**Coal Combustion Waste Impoundment
Task 3- Dam Assessment Report**

***E. W. Brown Plant
Auxiliary Ash Dam Complex
E.ON U.S. LLC
Harrodsburg, Kentucky***

**Project # 0-381
Assessment of Dam Safety
Coal Combustion Surface Impoundments
For the REAC Program**

Figure 5.2.1-1. Photo Showing the Dam Crest.

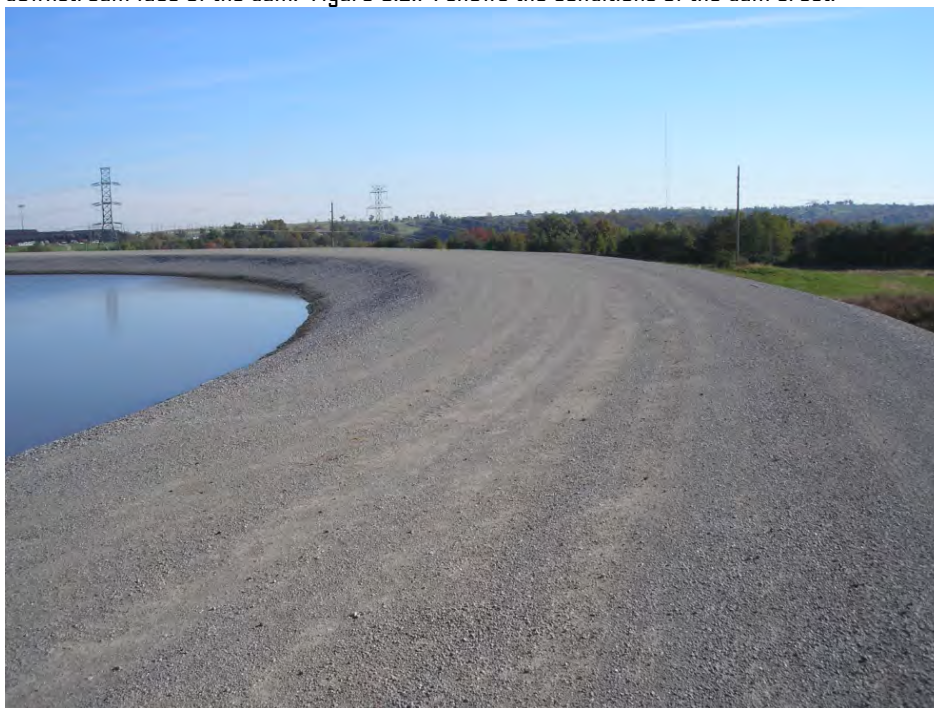
The dam crest had no signs of any depressions, tension cracks or other indications of settlement or shear failure, and appeared to be in satisfactory condition. The data did not indicate cracking along the crest or downstream face of the dam. Figure 5.2.1-1 shows the conditions of the dam crest.
